Restoring the Florida Everglades

Comments on the current reservoir plan for solving harmful algal blooms and restoring the Florida Everglades

William J. Mitsch

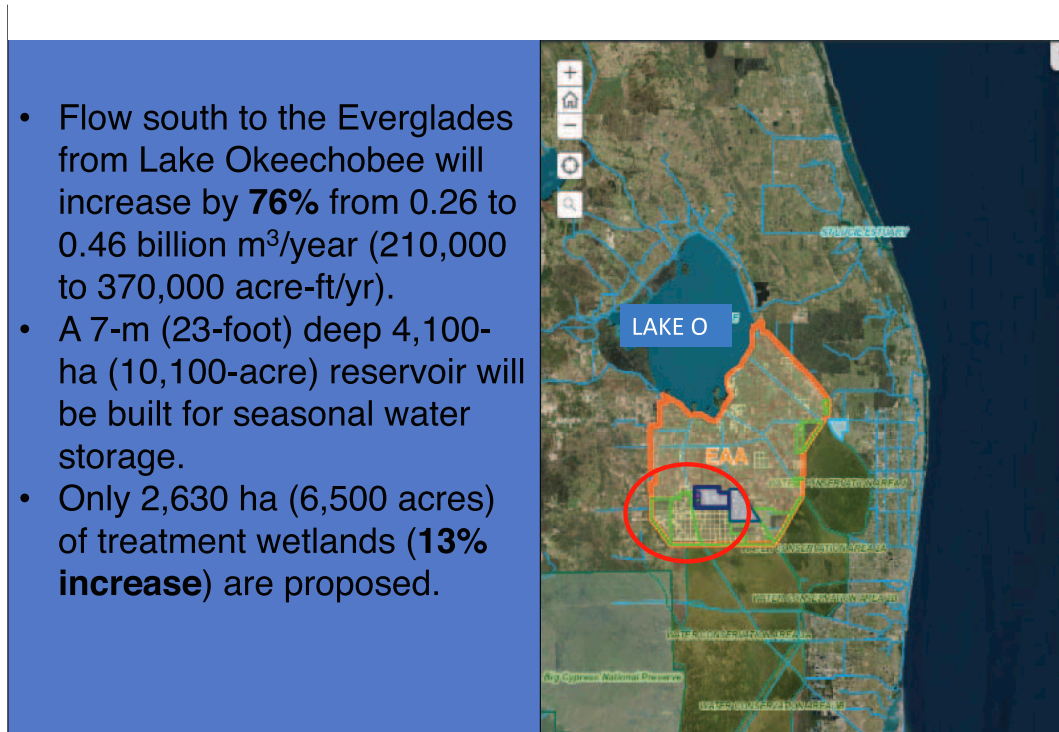
A current plan, referred to as C240A (Smith, 2018), calls for sending Lake Okeechobee water to an “EAA Reservoir” to be constructed about 50 km (30 miles) south of Lake Okeechobee with the following design: A 7-m (23-foot)-deep, 4087-ha (10,100-acre) reservoir with the capacity to store up to 300 million m³ (240,000 acre-ft or 78.2 billion gallons) of excess Lake Okeechobee water (Fig. 2). The plan also involves completion of a previously approved 6070-ha (15,000-acre) A-1 Flow Equalization Basin with a maximum water storage of 74 million m³ (60,000 acre-feet or 20 billion gallons) and the design and construction of 2630 ha (6500 acres) of shallow treatment wetlands, sometimes referred to by the SFWMD as Stormwater Treatment Areas (STAs), similar to the 25,600 ha (63,200 acres) of STAs already created or in progress

- The EAA Reservoir Plan is considered the future heart of this recent attempt to send water south in the Florida Everglades and is a good start of the discussion of solving water excess and scarcity problems. The Florida State Legislature and the South Florida Water Management District plan to increase the southerly flow by 76% and send an annual average of 0.45 billion m³ (121 billion gallons) of water south to the Everglades and Florida Bay is noteworthy.
- Nevertheless, there is considerable ambiguity in the plan and its model predictions about the quality of the water as it enters the greater Everglades south of the EAA Reservoir and through Miccosukee Tribal lands on its way to the Everglades National Park and Florida Bay. At a minimum, approximately 20,000 ha (50,000

acres) and hopefully more than 40,000 ha (100,000 acres) of treatment wetlands (STAs) need to be created or restored in proximity to the new EAA Reservoir; 2630 ha (6500 acres) of new treatment wetlands as described in the EAA Reservoir Plan will be grossly insufficient to protect the Everglades.

- The plan for an EAA Reservoir immediately south of Lake Okeechobee should be re-examined. For example, purchase of farmland at a fair price coupled with conversion of that land to treatment wetlands (perhaps as much as 60,000 ha (150,000 acres) from the 280,000 ha (700,000 acre) EAA in lieu of construction of a ~\$2-billion EAA reservoir is a reasonable alternative to the reservoir for water storage and water quality and should be examined. Additionally, state-owned lands currently leased to agricultural tenants could be incorporated in any comprehensive review of alternatives. Providing treatment wetlands to achieve water quality goals in the Florida Everglades is closer to true “restoration”; creation of large difficult-to-manage deep reservoirs is not. Federal acceptance of this plan needs to be conditioned with the requirement of adequate stormwater wetlands (STAs) and flow equalization basins (FEBs), to mitigate the chances of falling short.

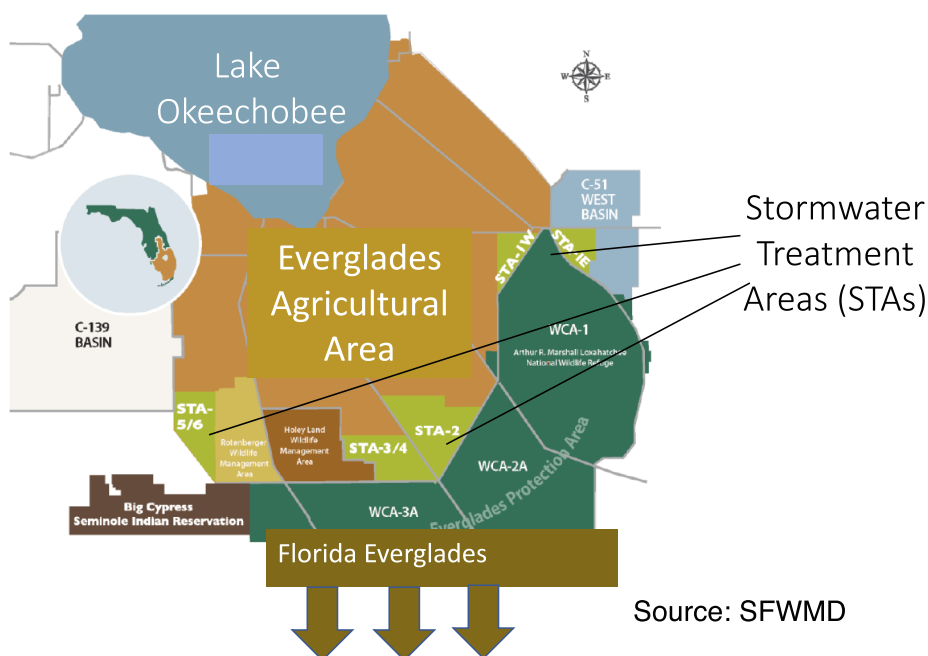
Fig. 3. Illustration of location of current treatment wetlands (called locally STAs or stormwater treatment areas) south of the EAA. There is no clear indication if these wetlands will receive double duty with additional inflows from the EAA Reservoir Plan. Currently 25,600 ha (63,200 acres) of these wetlands have been created or are on the drawing boards to be created. Our conservative estimate is that 40,000 ha (100,000 acres) more of these treatment wetlands will be needed to ensure that the EAA Reservoir Plan will be successful.

water volume and flow. The flow south to the Everglades will increase by 76% from 0.26 million m³/year (210,000 acre-ft/year or 68 billion gallon/yr) to 0.46 billion m³/year (370,000 acre-ft/yr or 121 billion gallon/yr) according to the EAA Reservoir plan (Smith, 2018). Despite the 76% increase in flow, the project shows only an 11% increase in treatment wetlands of 2630 ha (6500 acres) to improve water quality directly. I estimate an additional minimum of

at least 17,500 ha (43,000 acres) of treatment wetlands (STAs or passive wetlands) will be needed to treat the water flowing south and have recommended previously that 40,000 ha (100,000 acres) should be set aside for treatment wetlands (Mitsch, 2016) to allow for a safety factor of 2, a reasonable design allowance for this type of ecological engineering project.
